Proposal Request

Project:	Twin Falls Fire Station 2	PR No.:	PR-02
Project No.:	20-041	Date Issued:	May 27, 2022
Owner:	City of Twin Falls 214 Cheney Drive Twin Falls, ID 83301	Issued To:	Starr Corporation 2995 E 3600 N Twin Falls, ID 83301
Contract Date:	April 12, 2022	Attn:	Jason Derricott

ITEM 1: PR-02 Dedication Plaque Design and Room Signage Schedule

Sheet No: A4.11

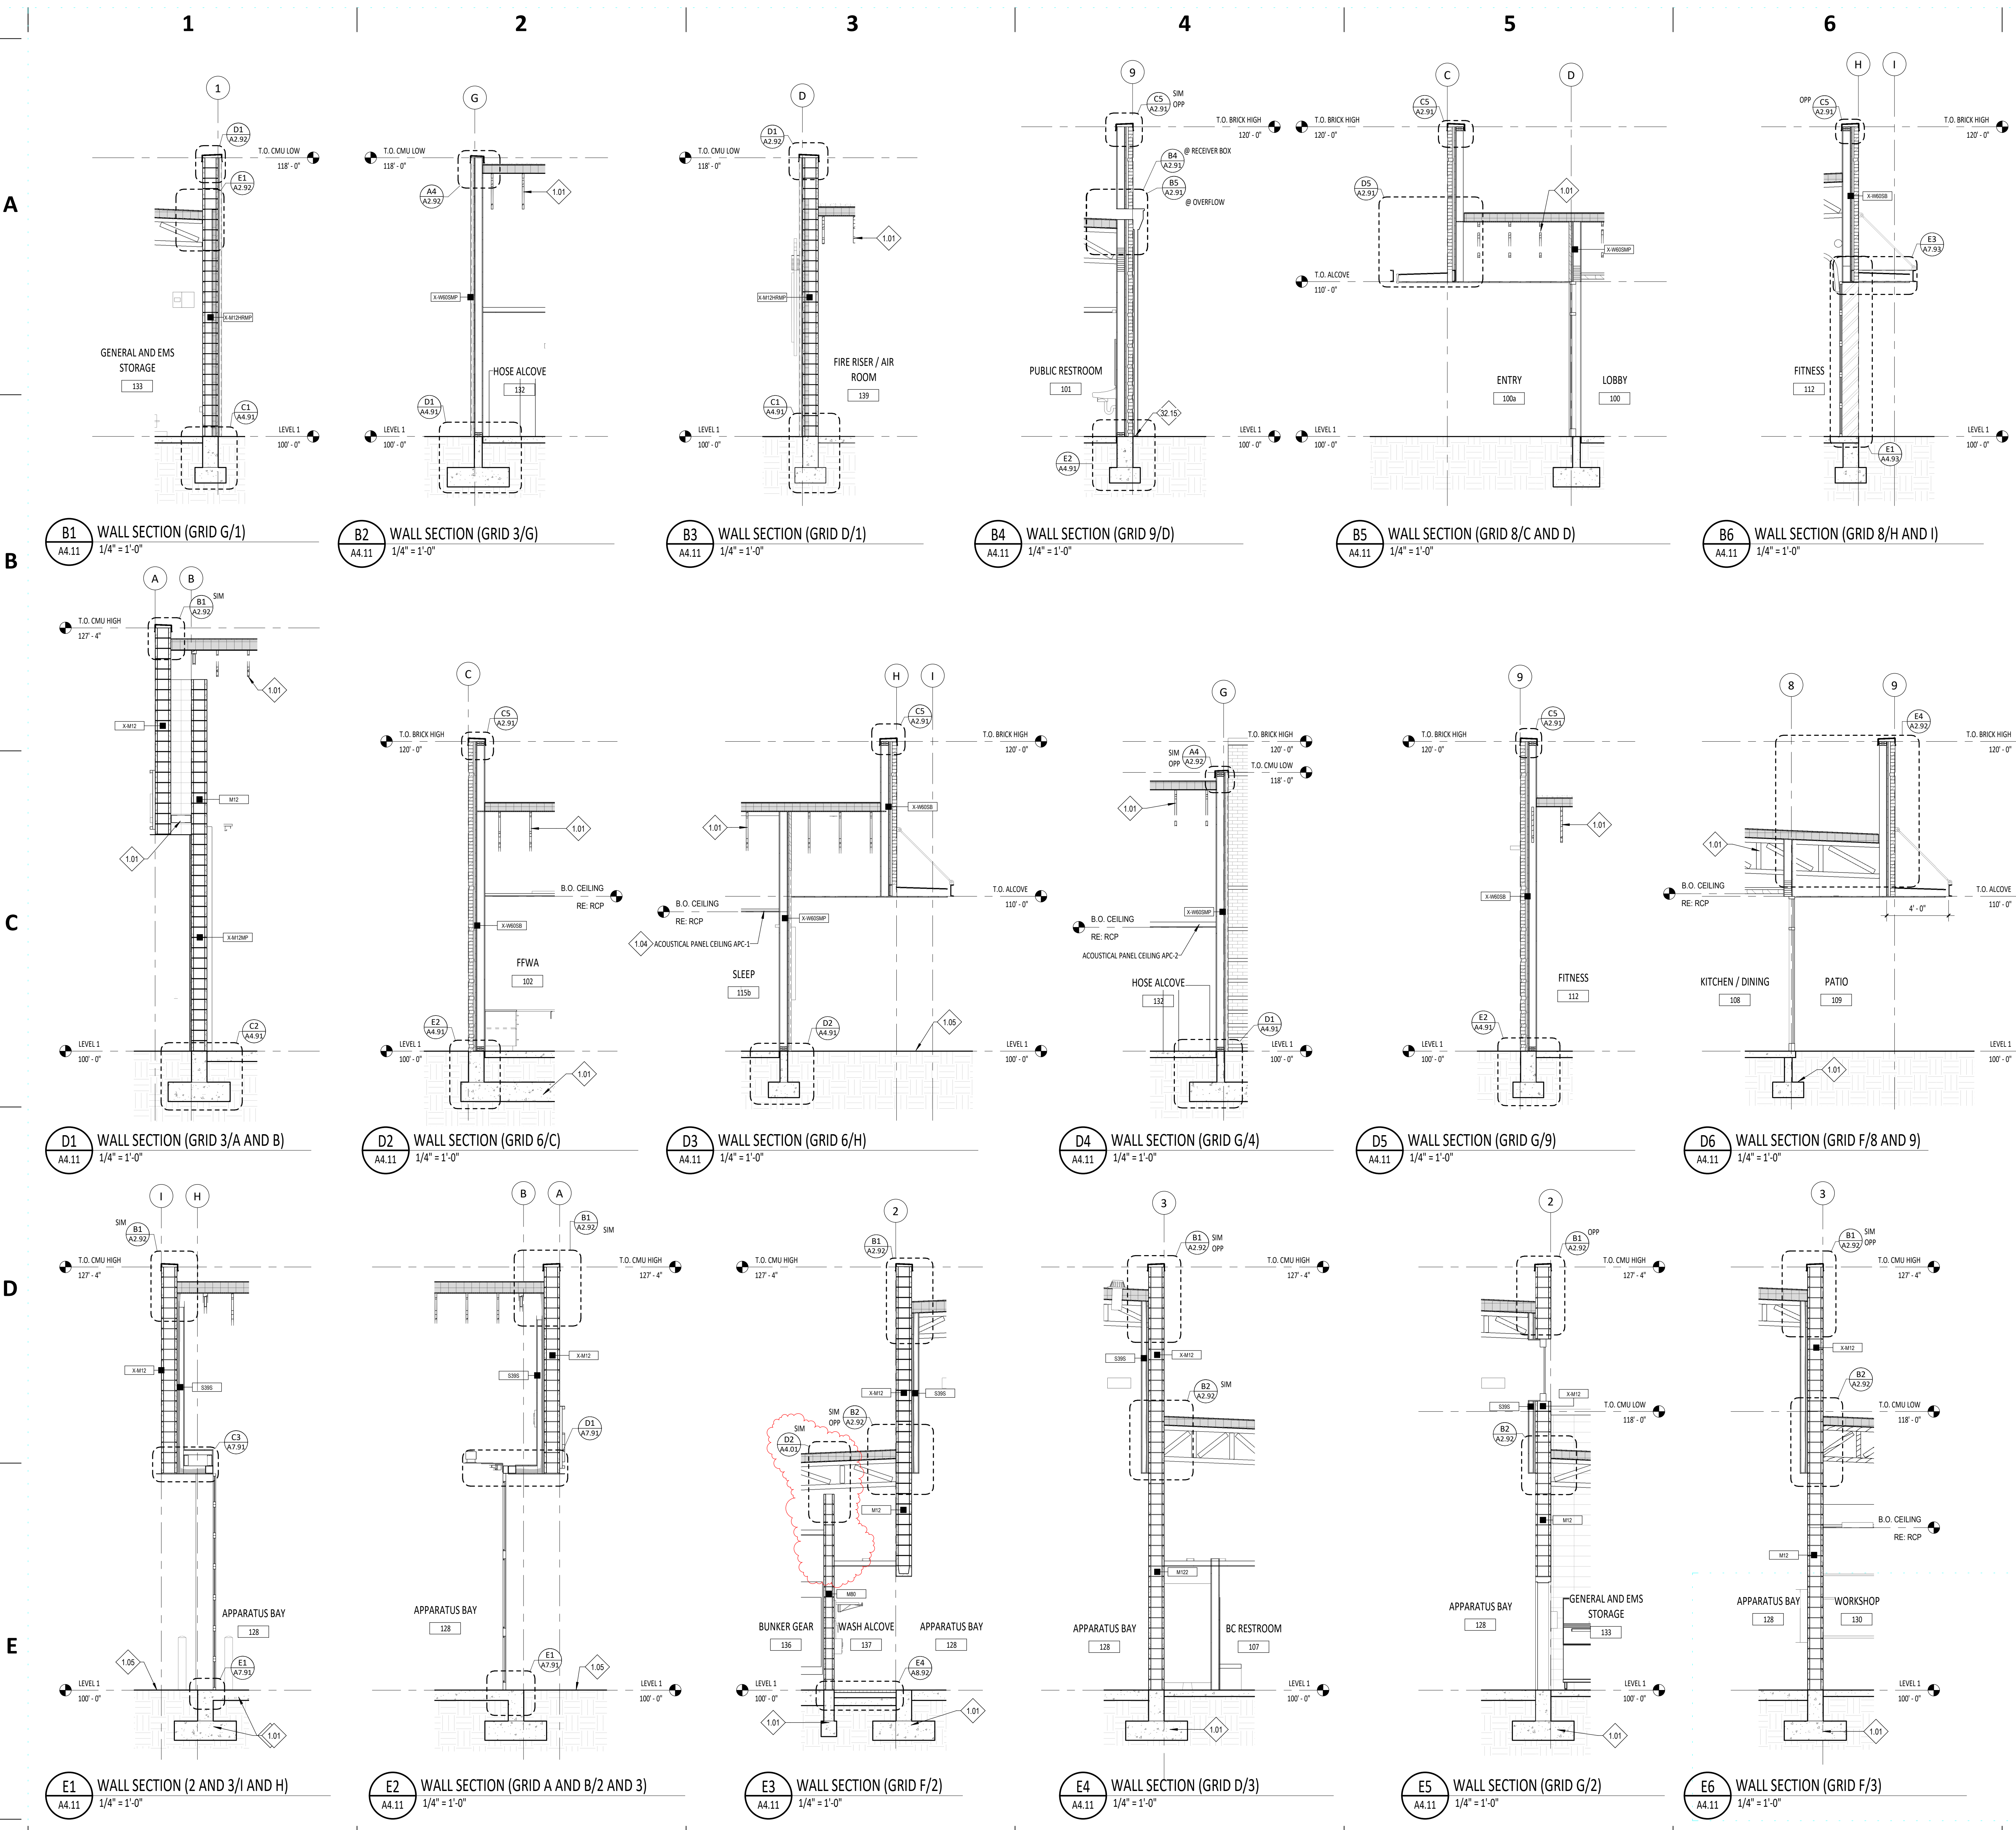
- Indicated location of detail D2/A4.01

E1 LEVEL 1-CEILING PLAN
A9.01 1/8" = 1'-0"

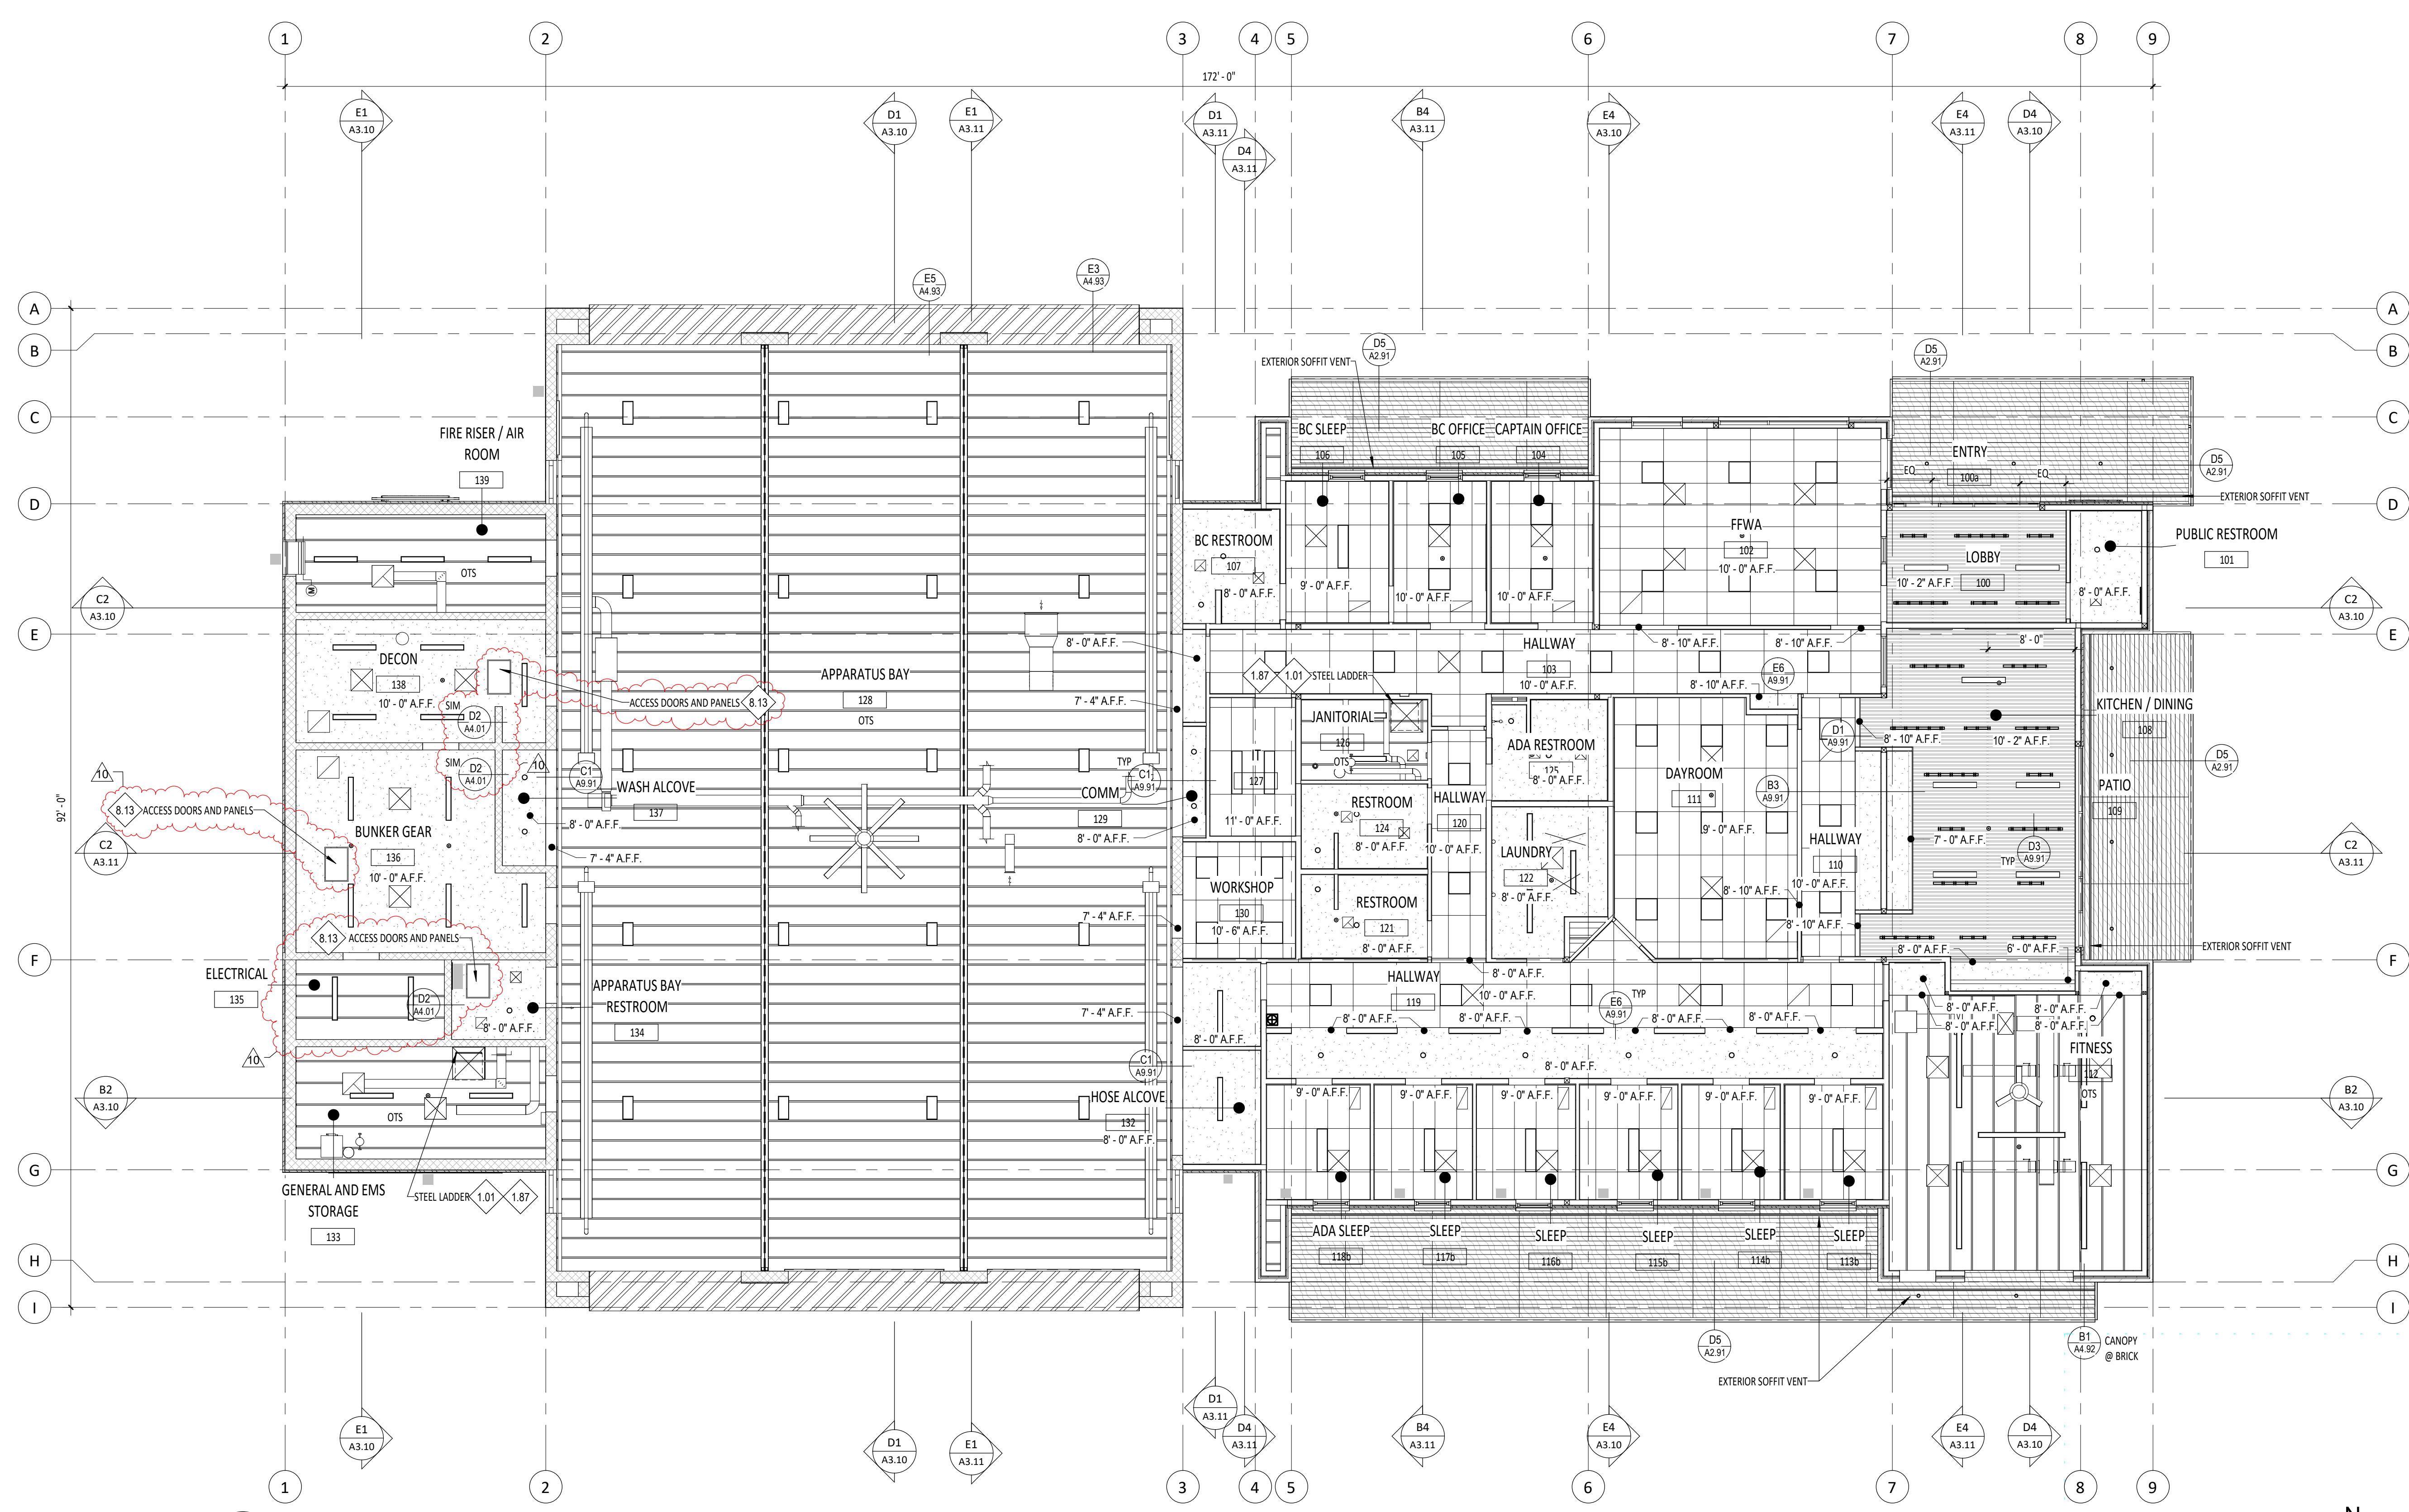
- Indicated location of details D2 on A4.01.

- Showed location of access panel within rooms DECON 138, BUNKER GEAR 136 and APPARATUS BAY RESTROOM 134.
- Ref Note: 8.13 24" X 36" DOOR. PROVIDE 3' MIN HEAD ROOM ABOVE CEILING.

LEVEL 1 - DOMESTIC WATER PLAN
SCALE: 1/8" = 1'-0"

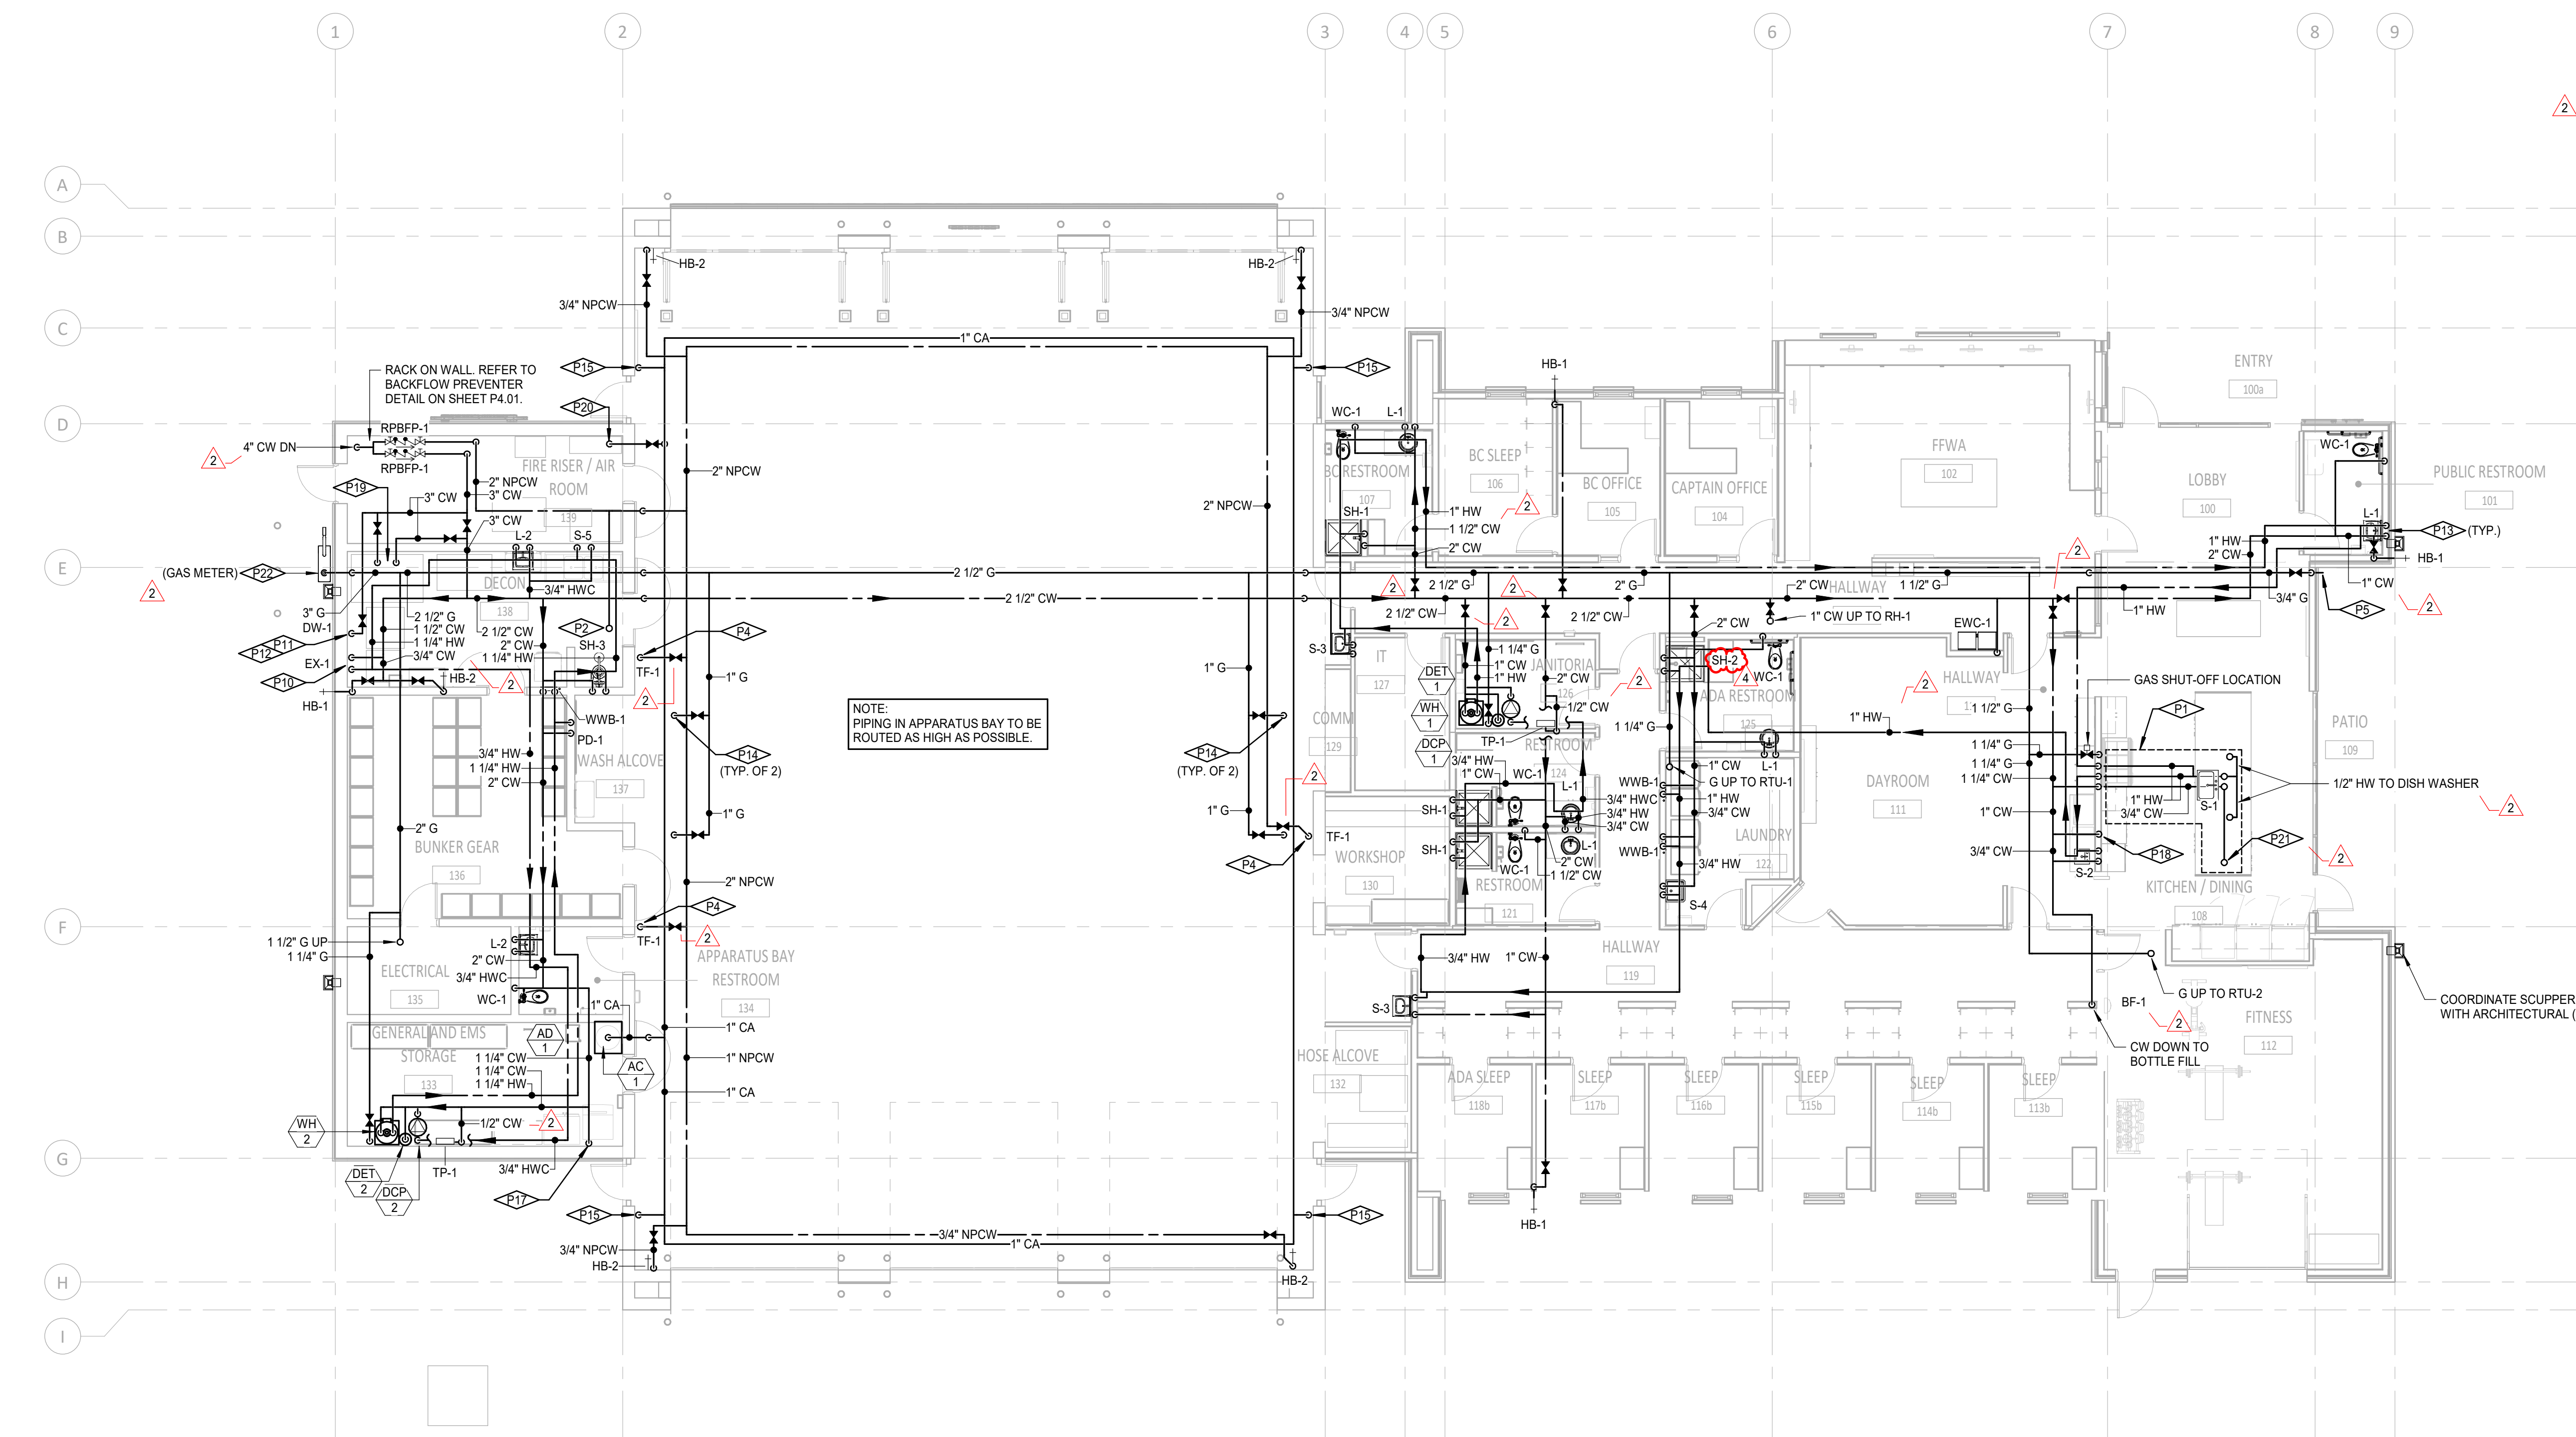
- Indicated location of SH-2
